SAFETY EVALUATION OF THE INDIAN POINT NUCLEAR GENERATING UNIT NO. 3

Docket No. 50-286

Issue Date: September 21, 1973

SAFETY EVALUATION REPORT
BY THE
DIRECTORATE OF LICENSING
U.S. ATOMIC ENERGY COMMISSION
IN THE MATTER OF
CONSOLIDATED EDISON COMPANY OF NEW YORK, INC.
INDIAN POINT NUCLEAR GENERATING UNIT NO. 3
DOCKET NO. 50-286

FIGURE 6-4

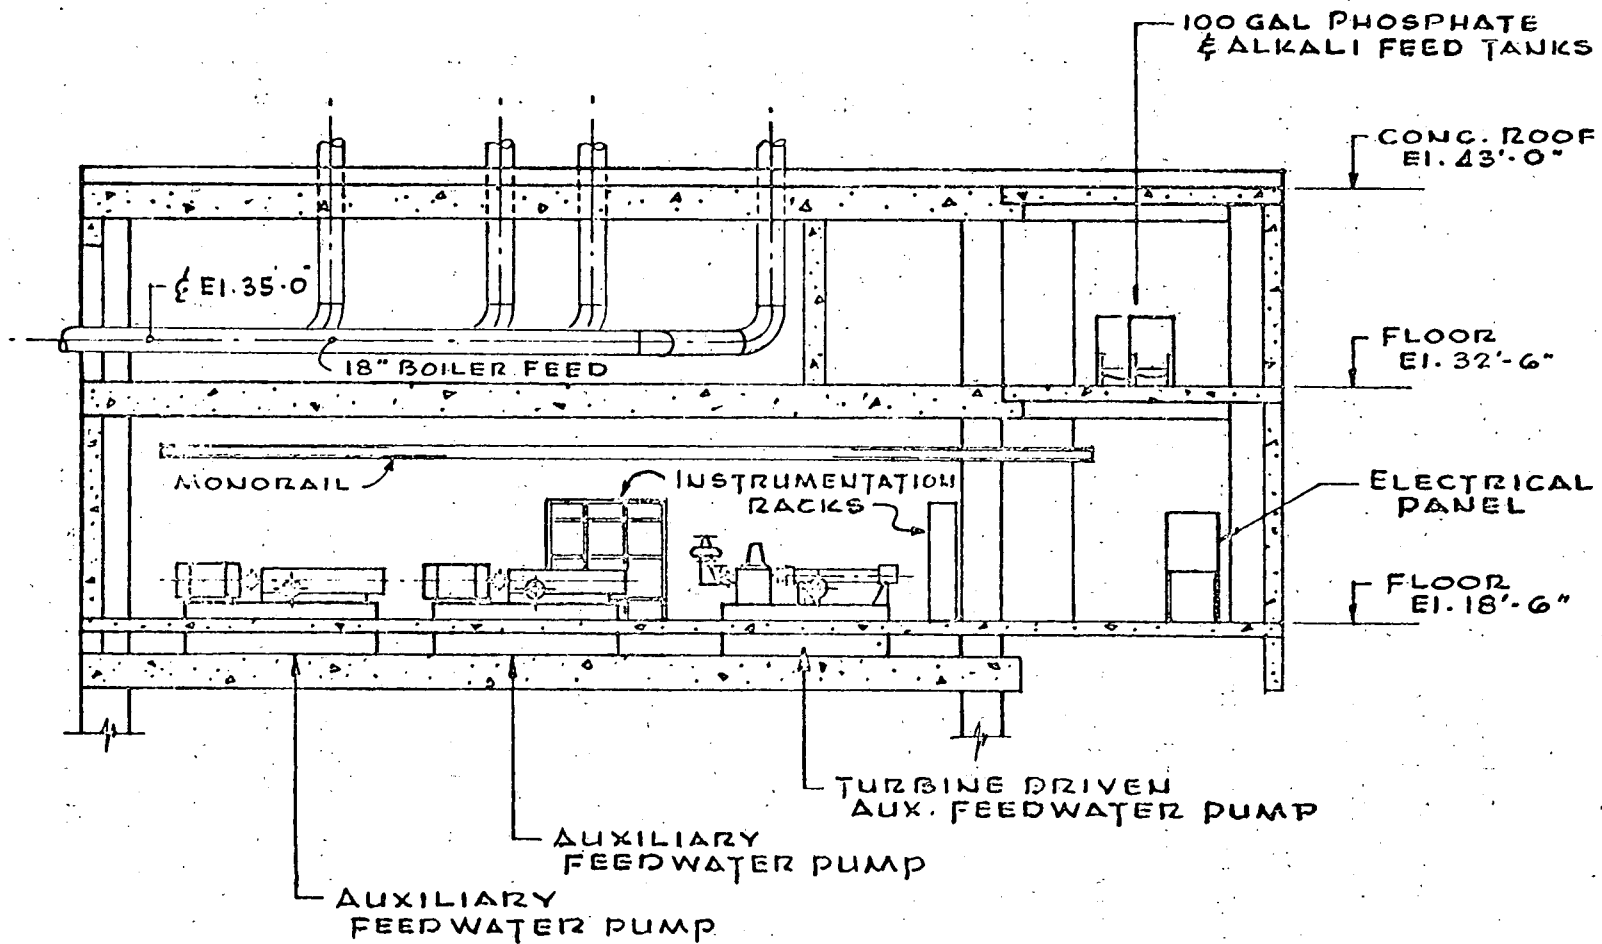
6.4 Auxiliary Feedwater System

The auxiliary feedwater system removes heat from the secondary system whenever there is a loss of normal feedwater. Normal feedwater can be lost by pipe breaks, pump failures, valve malfunctions, or loss of offsite power. The auxiliary feedwater system also influences the fuel cladding peak temperature following a small break in the primary coolant system.

Auxiliary feedwater is supplied by two motor-driven auxiliary feedwater pumps and one steam turbine-driven auxiliary pump. Each motor-driven pump will deliver 400 gpm (at a head of 3200 feet) and the

The staff has reviewed these modifications and found them acceptable.
